GNH	Great Northern Highway - Muchea to Wubin Upgrade - Stage 2				
		Memorandum (MEM)			
MUCHEA TO WUBIN	Doc No.	GNH-CN12-EN01-LET-0001	Rev	1

Contract No. & Work Identifier:	CN12-EN01	Client Contract No.:	10/13	Date:	5/07/2018		
Contract Title:	Bindoon Bypass						
То:	Mark Jefferies						
Copies:	John Braid; Norm Fox						
From:	Lisa Boulden						
Subject:		Great Northern Highway Muchea to Wubin Upgrade – Stage 2: Bindoon Bypass (Assessment Number 2135) – Request for Change to Proposal

2000	cess Road fo	r Lot 37
Figure: 13 Drawing No GNH-CN12	-E-GD-EA-00105	lssue C
Task No Bindoon Approval	Drawing Status / Othe Current as of

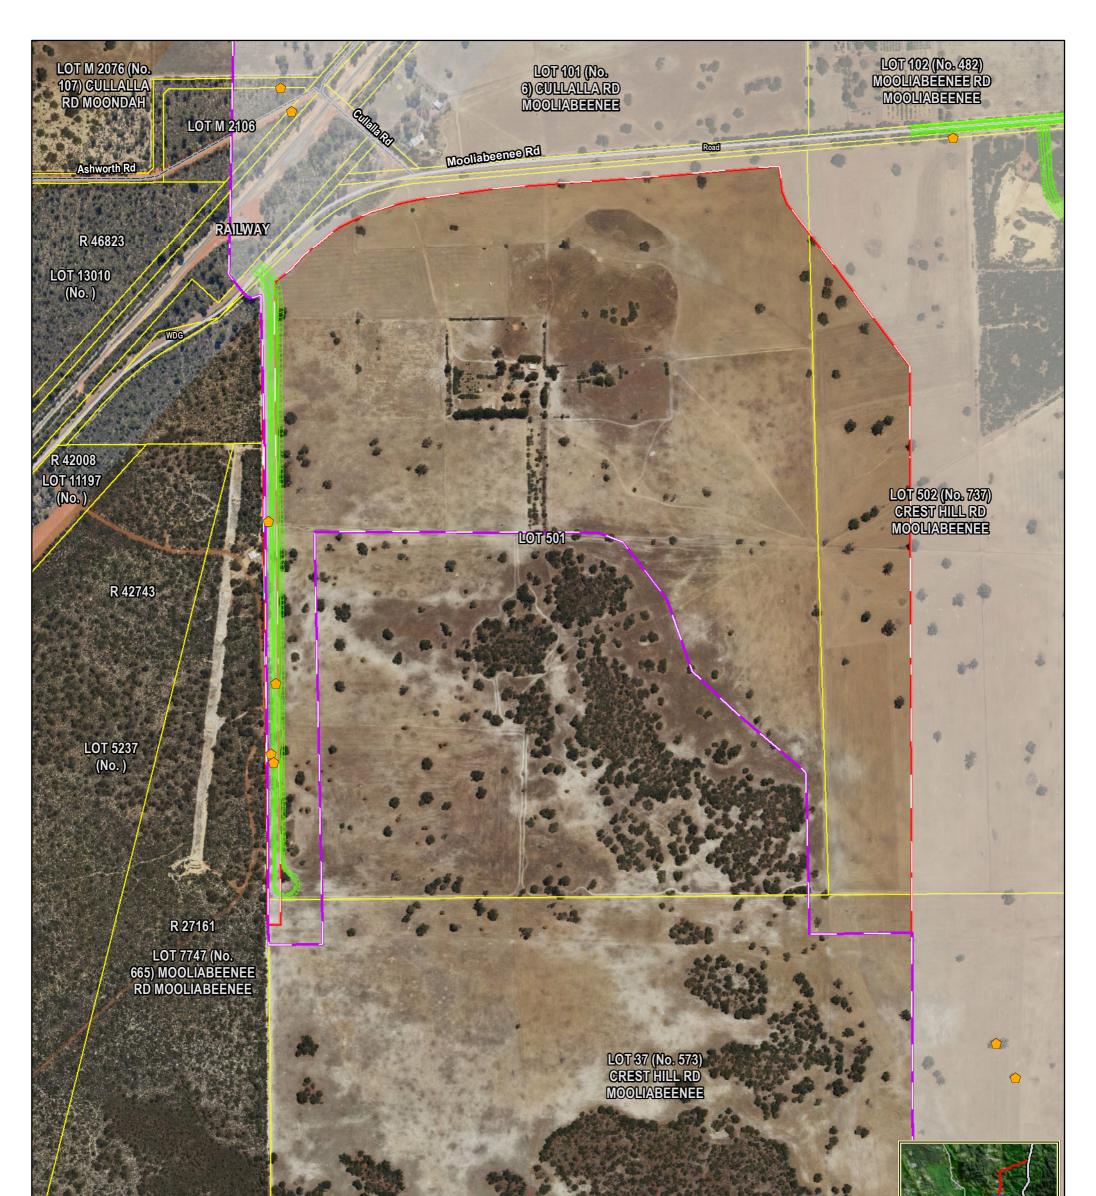
The current design for the local access road to the severed portion of Lot 37 Crest Hill Road, Mooliabeenee has the road situated along the boundary with the adjacent Bindoon Rifle Range. Main Roads has recently become aware that this location may bring the road into conflict with the 'danger zone template' of the rifle range. If the 'danger zone template' is impacted by the public road, it may not be acceptable for the maintenance of the safe operation of the rifle range and has the potential to impact ongoing use of the range for this purpose. Accordingly, Main Roads is reviewing options that consider the needs of the rifle range, including potentially changing the location of the local access road, introduction of safety gates, and signage on the local road for periods of rifle range operation. The change to the development envelope at this location allows for relocation of all or part of the proposed local road to facilitate a workable solution with consultation and input from all affected parties (**Figure 13**).

The proposed change to the development envelope encompasses largely cleared paddock with isolated mature trees. These trees will be surveyed to identify if they contain hollows used by or suitable for use by Black Cockatoos. Any change to the location of the local access road will be designed to avoid these trees. No additional impacts are anticipated as a result of this change.
